Accessibility Survey

City of Downey Cherokee Drive - Downey Avenue To Lakewood Boulevard

Date of Inspection
2/2/2017

Disability Access Consultants

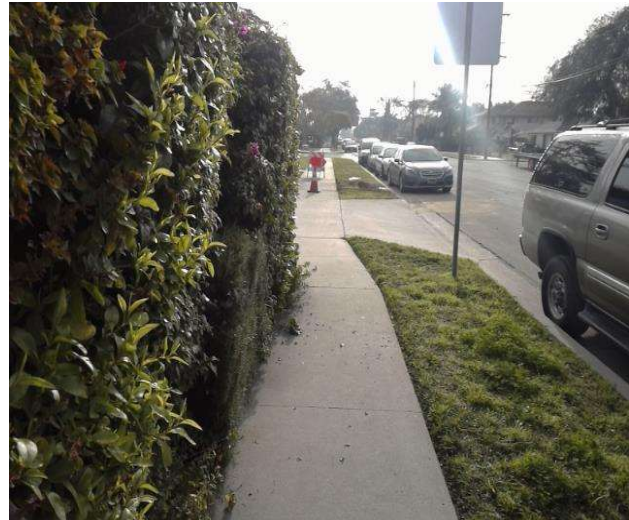
Sidewalk width at the obstruction is not compliant.

On-Site Finding 38.00 inches

Sidewalk width at the obstruction shall have the recommended value.

Change In Level West Of Brookshire Avenue @ 33.945853172344, - 118.125109970570

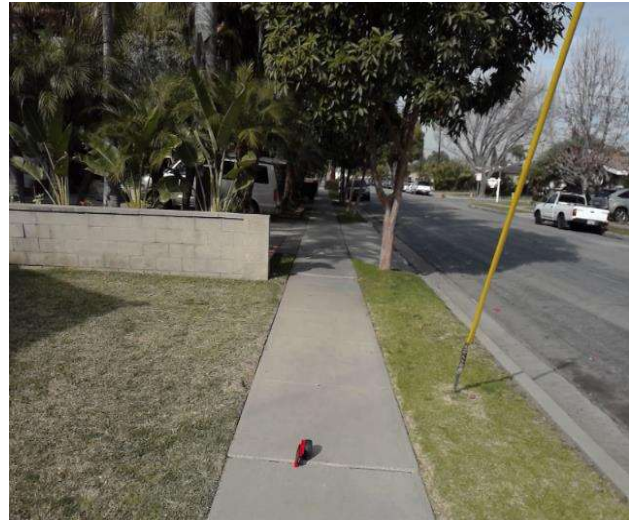
There is a change in elevation greater than recommended value.

On-Site Finding 0.62 inches

Ensure that the change in elevation is within the recommended value.

Change In Level West Of Brookshire Avenue @ 33.945922, -118.125154227018

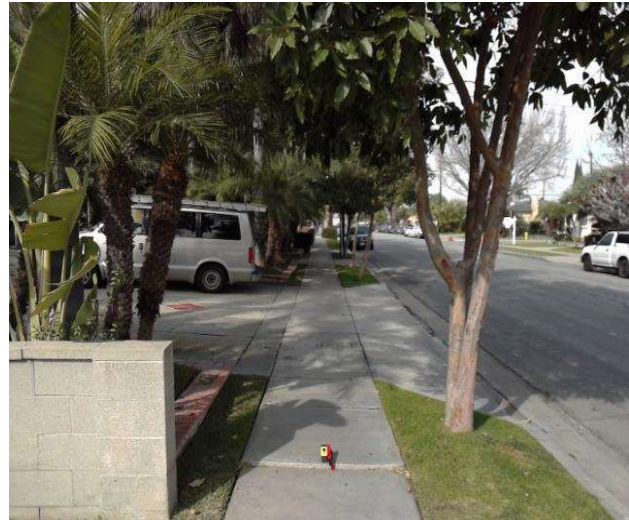
There is a change in elevation greater than recommended value.

On-Site Finding 1.25 inches

Ensure that the change in elevation is within the recommended value.

Change In Level West Of Dolan Avenue @ 33.947035788035, -118.127448856831

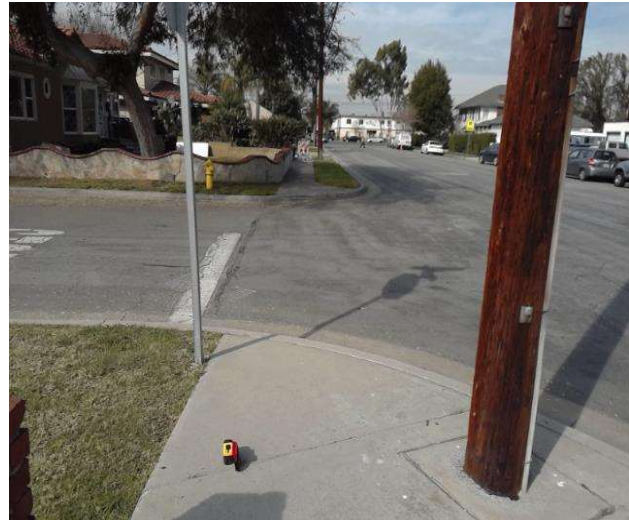
There is a change in elevation greater than recommended value.

On-Site Finding 0.62 inches

Ensure that the change in elevation is within the recommended value.

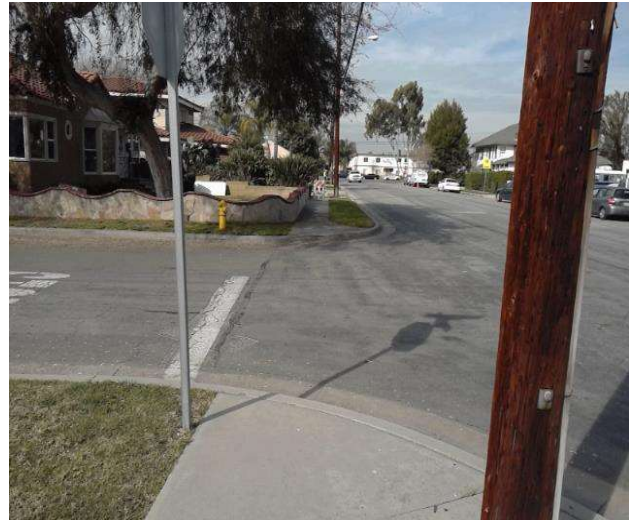
There is a curb on the designated path of travel.

On-Site Finding Not Compliant

Provide a compliant curb ramp.
